# Joint civil society organisation analysis and recommendations on the Leaked Delegated Act draft on Climate Mitigation and Adaptation Taxonomy

April 2021

### 3.1. The first criterion is automatically met, hence useless

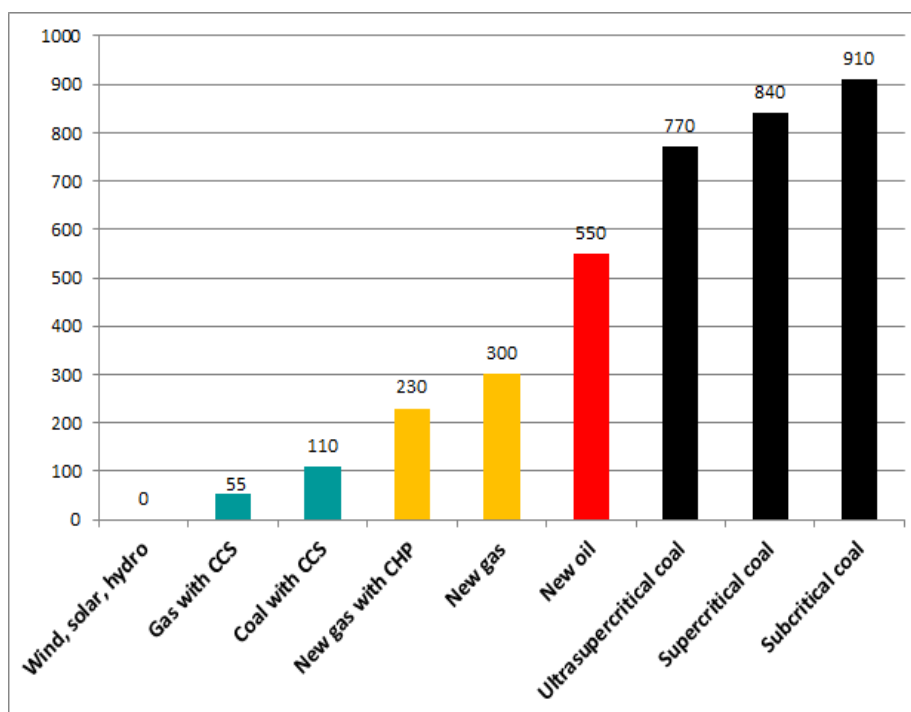
The first criterion of the Commission's leaked proposal states that a gas cogeneration plant can only be tagged "green" if it replaces a high-emitting combined heat/cool and power generation facility that has at least the same capacity.

- *How much coal and oil power capacity could be closed between now and 2025?*  
Using the [Europe Beyond Coal database](#), we find that as of today **35 Gigawatts (GW) of coal-fired power plants are already scheduled to close between now and 2025** in the EU (out of the total 142 GW of operational coal plants in the EU today) and tens of additional GW need to close by 2025 in a 1.5°C pathway. This figure is only for coal power plants - it does not even include coal CHP plants, coal heating plants, oil power plants, oil CHP plants and oil heating plants, all of which are included in the leaked proposal, and which would further increase the number of GW due to close by the end of 2025.

- *In comparison, how much gas cogeneration is in the making in the EU?*  
According to [Global Energy Monitor](#), **8.3 GigaWatts (GW) of gas-fired cogeneration plants are under construction or planned in the EU : this is 4.3 times less** than the 35 GW of coal-fired power plants already scheduled to close between now and 2025.

- As a result, **up to 100% of gas plants with cogeneration built until 2025 could be eligible to be labelled as green, as there is far more coal power closing than gas CHP opening.**

- Even worse, there will be room for labelling much more. **The leaked proposal creates a direct incentive to build even more gas cogeneration plants than already planned, while failing to close any more coal plants.** This first criterion of the leaked proposal is not only ineffective - it is harming the environment.

- **Including power-only coal plants in the proposal is the most outrageous part of the proposal**, as there is a huge, obsolete and polluting coal plant fleet in Europe that is *already* closing at increasing speed because most EU coal plants are losing money: according to [Carbon Tracker Initiative analysis](#), in 2019 four in five EU coal power plants were unprofitable and utilities lost billions because of coal. Matt Gray, Head of Power & Utilities at Carbon Tracker and co-author of the report, said: “*EU coal generators are haemorrhaging cash because they cannot compete with ever-cheaper renewables and gas and this will only get worse. Policymakers and investors should prepare to phase out coal by 2030 at the latest.*”

### 3.9. Fossil gas is far more carbon-intensive than previously thought

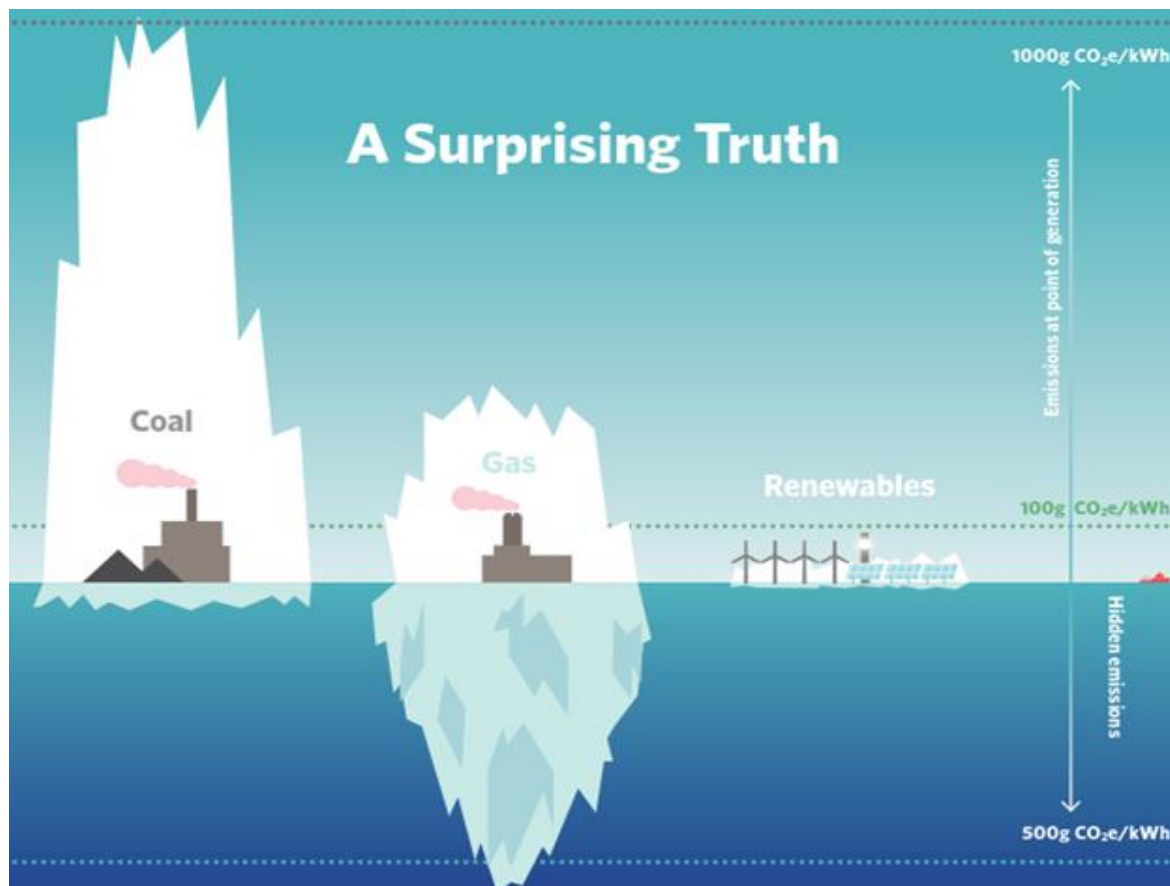
Greenhouse gas emissions from fossil gas are way higher than previously thought, because of hidden emissions due to fugitive methane emissions along the full life cycle, as presented in a [briefing coordinated by Climate Bond Initiative](#):

- Methane matters because its impact on climate change is 84 times greater than CO<sub>2</sub> over a twenty-year timeframe.
- If gas leaks more than 3% of its methane content, it is worse for the climate than coal.
- Methane emissions attributable to oil and gas production are up to 40% higher than thought.
- The EU imports most of its gas, increasingly in the form of highly inefficient LNG, and always from sources with high methane footprints. 40% of EU gas imports come from Russia, the country with the highest contribution to global methane emissions from oil and gas; and 36% of EU gas imports come from the US as liquefied natural gas (LNG), a product that uses a further 25% to fuel the process of liquefaction and transportation: this extra amount means that the power produced from LNG emits more emissions than power from coal.
